Serial No. 10/615,400
Amdt. dated May 6, 2005
Reply to Office Action of November 9, 2004

REMARKS

Amendments to the Drawings:

Fig. 3
(Prior Art)

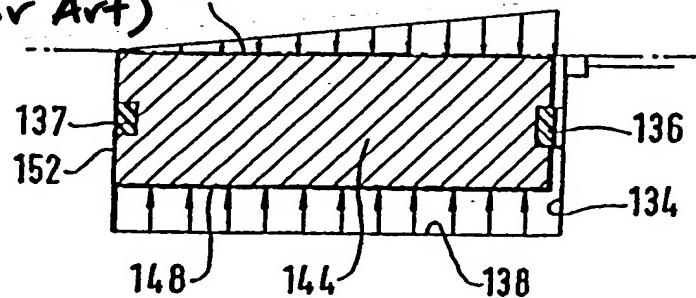
The attached Replacement Sheet of drawings changes figure 3. This sheet replaces the original sheet which includes figures 2-6. As shown in the attached Annotated Sheet, figure 3 is identified in the drawing as Prior Art.
